1-NSW-70 (Sheet 1 of 2)
Upper Containment Ventilation
Unit 3 Return Line

LIVSEY & COMPANY, INC.
DONALD C. COOK NUCLEAR PLANT

DWN: LGR	DATE: 7-14-71	CONTAINMENT BLDG
CKD: GN	DATE: 7-20-71	DWG. NO. 1-NSW-70- REV 5
ISSUED		SH 1 OF 3
REF. DWG. 1-5489A

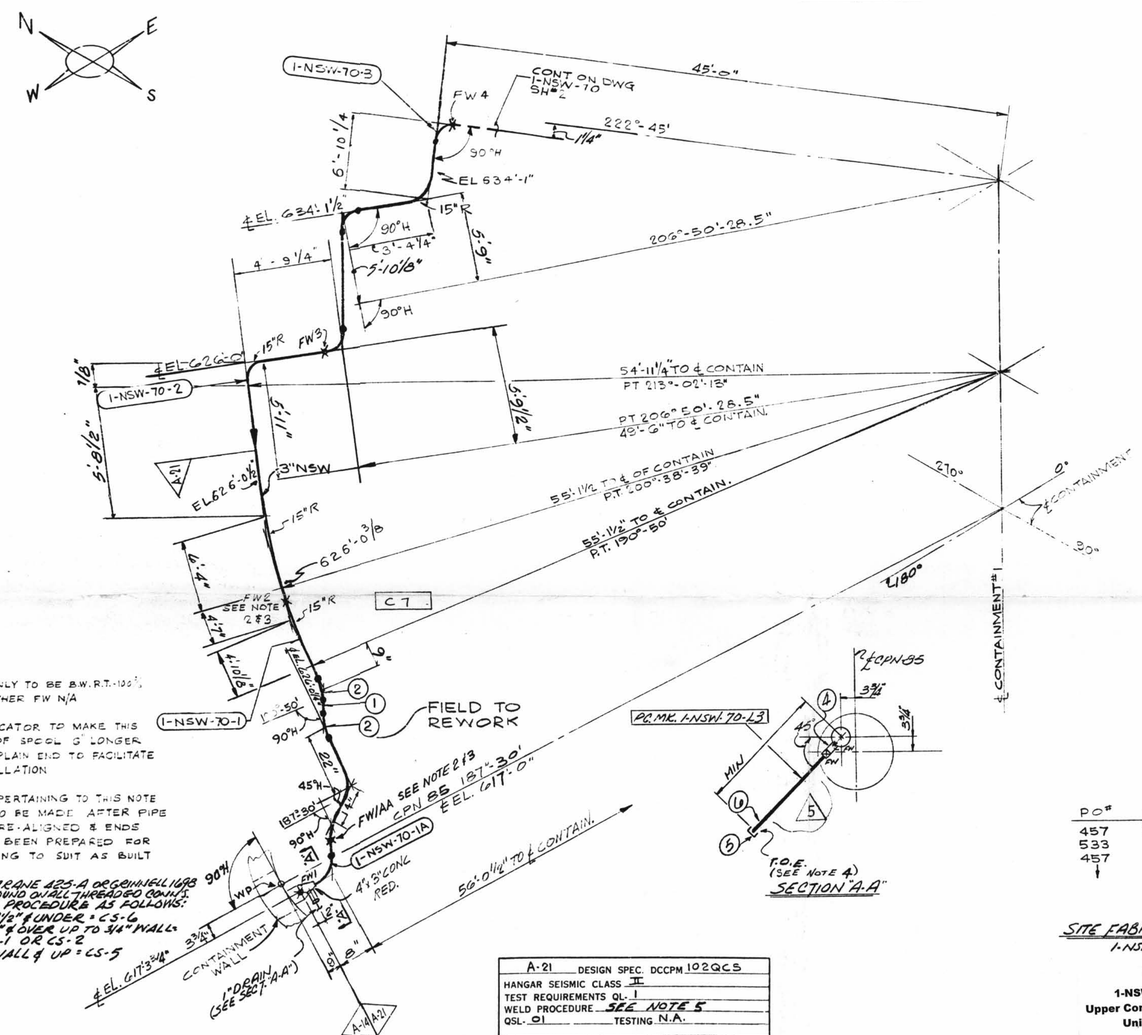
REV.	DATE	DR CHK	DESCRIPTION	REMARKS
1	12/2/71	SG GN	RELEASED PIPING AT CPN. ADDED: FW1AA; PC MK 1A; P.O.#; DESIGN CODE STAMP; NOTES 2&3; TOTAL NO. OF FW. REVISED: WELD PROCEDURE. PER DWG 1-5489A.	FIELD ACTION REQ'D. / FAB ACTION REQ'D.
2	4/10/72	JG GN	REVISED PIPING & ADDED NOTE FOR FIELD REWORK FOR PC MK 1 & 1A. ADDED: ITEMS 1 & 2. DELETED: WELD PROCEDURE; TOTAL NO. OF FW'S. PER A.E.P. DWG 1-5489A-2.	FIELD ACTION REQ'D.
3	1-28-73	JJJ HJB	ADDED: 1" DRAIN, SECTION "A-A" LIVSEY PC. MK. 1-NSW-70-13, NOTE 4, ITEMS 3 THRU 6 INCLUSIVE. (PER AEP ARRG. 7.1-540 9A-3)	FIELD ACTION REQ'D. —
4	1/11/74	BR DTG	ADDED: NOTE #5, DIM. 1'4" & 10 1/8" 3'-4 1/4", 5'-9", 5'-10 1/8", 4'-9 1/4", 3'-11 1/8", 5'-3 1/8", 6'-4", 4'-7", 4'-10 1/8", 22", 14", EL. 626'-0 1/8", EL 634'-1", 626'-0 3/8", DIM. 5'-9 1/2" WAS 5'-9", 54'-11 1/4" WAS 55'-11 1/2", 5" WAS 8 1/8", EL 634'-1 1/2" WAS 634'-1", 626'-0 1/8" WAS 621'-0" PER AS BUILT DWG A.E.P DWG. NO. 1-5489A-4	NO ACTION REQ'D.

5	3/2/77	WMC	AS PER RFC-DC-01-2007 REMOVED VA. FROM SECTION A-A
